ANN ARBOR HISTORIC DISTRICT COMMISSION

Staff Report

ADDRESS: 112-114 W Liberty Street, Application Number HDC21-156

APPLICATION: The applicant seeks HDC approval to rebuild the third-floor roof 1'10 ½" higher; rebuild the third-floor north wall with new openings; add a 35 sf stair enclosure; add a steel walkway across the second floor roof to a steel fire escape stair leading to the rear of the building.

Adjacent Building Windows - Modern Replacement Windows

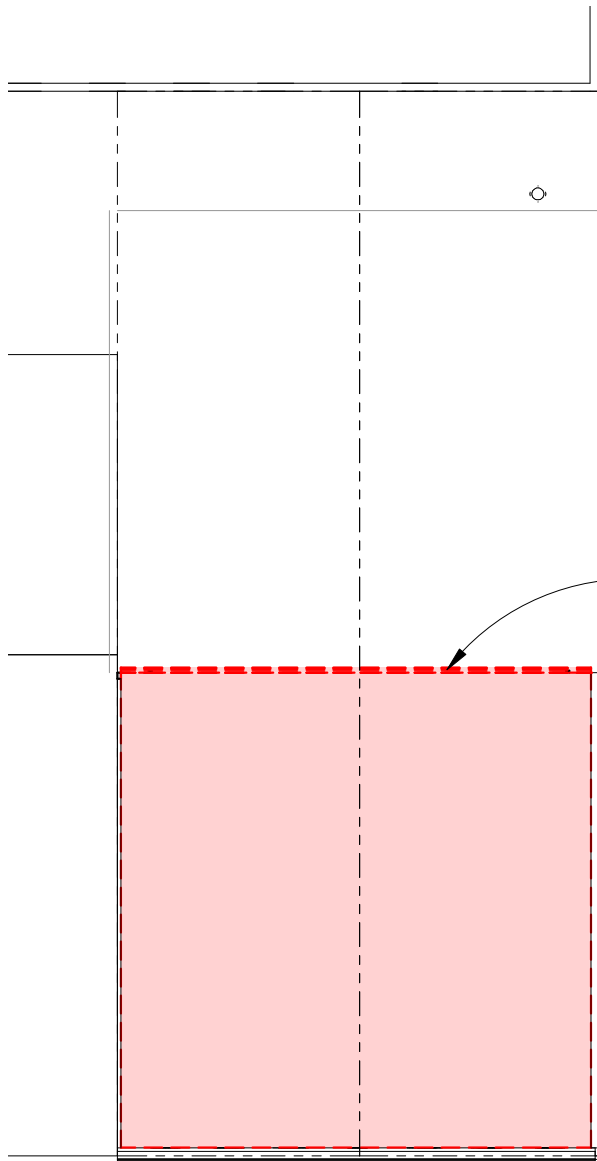
4. Placing fire escape stairs at the rear of the building makes them inconspicuous. No character-defining features would be compromised and the work is reversible. The placement of steel stairs 6" from the neighboring building's windows is unfortunate, but staff believes it is acceptable as long as building codes are met. The affected windows on Schwaben Hall are all modern replacements.

2 Fire Escape Enlarged Stair Plan
 H-08 2' 4' 6' 3/8" = 1'-0"

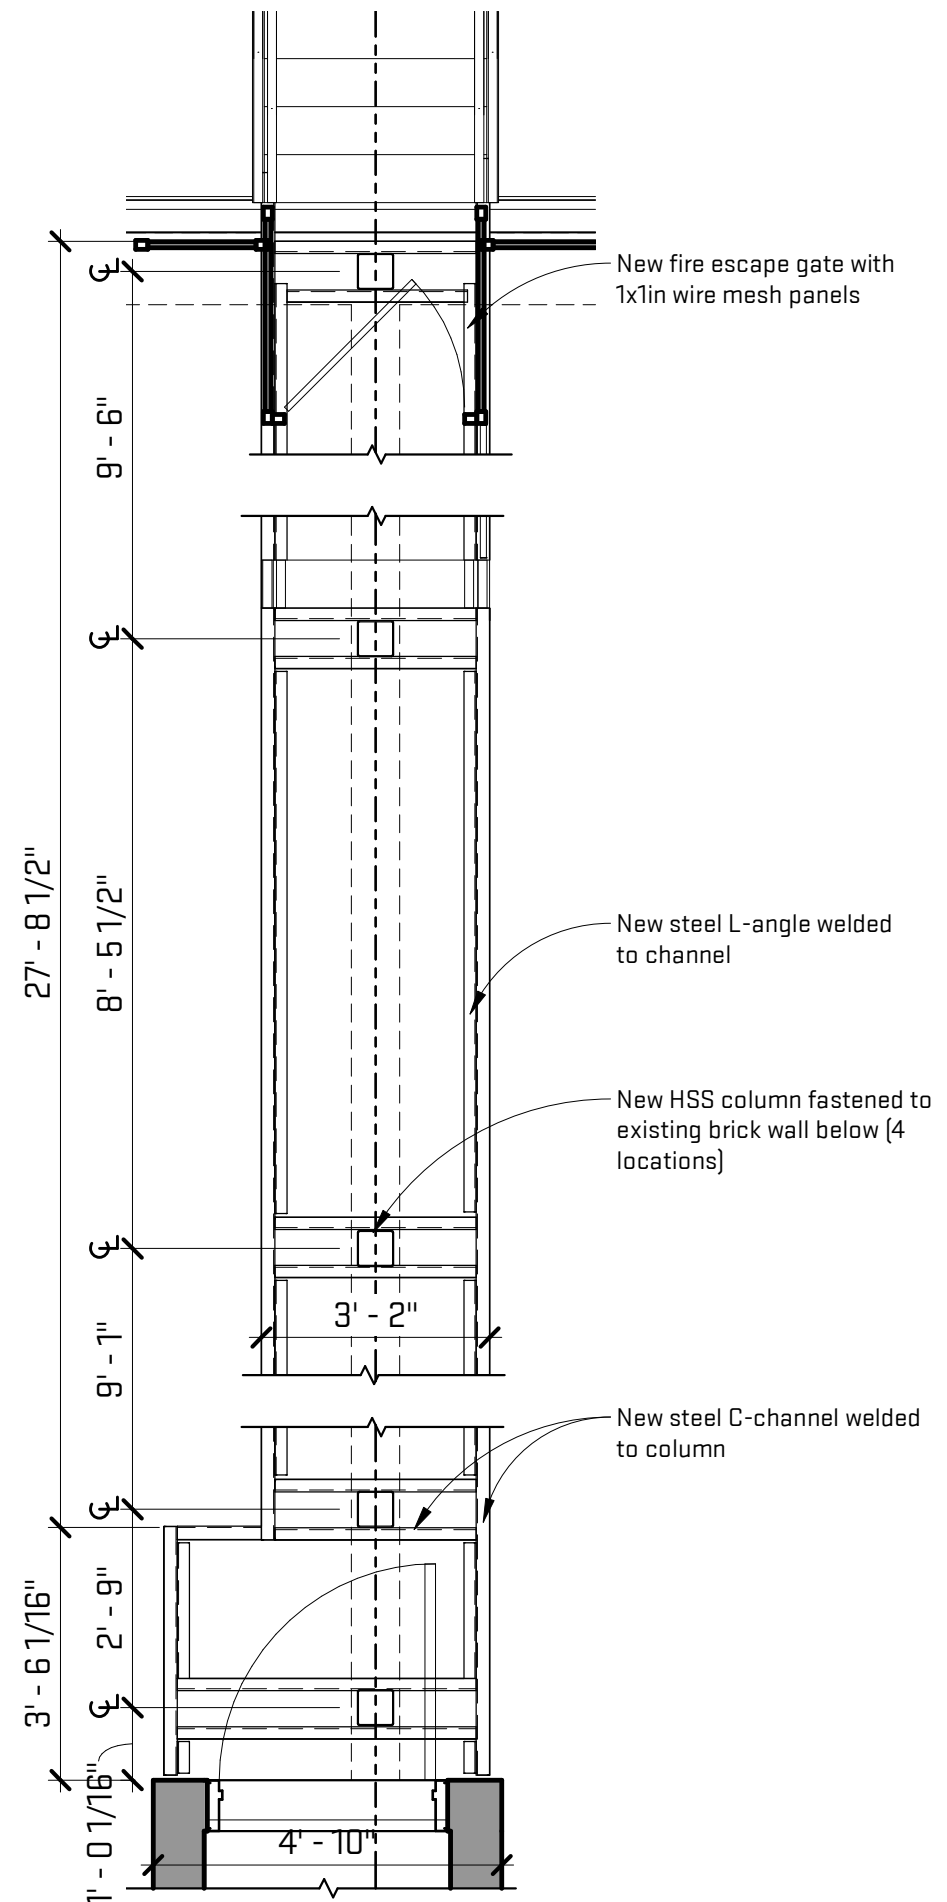
3. The steel walkway and fire escape are a required second means of egress for third-floor residential use. The walkway is located on the center of the second-floor roof. It is 38" wide, has steel mesh guardrails on both sides, and a gate at the north end leads to a steel fire escape stair. The stair descends north six feet to a landing, then turns 90 degrees to the west for two more runs of stairs. Those stairs are noted to be at least 6" from the Schwaben Hall building to the north, which appears to be built to the lot line.
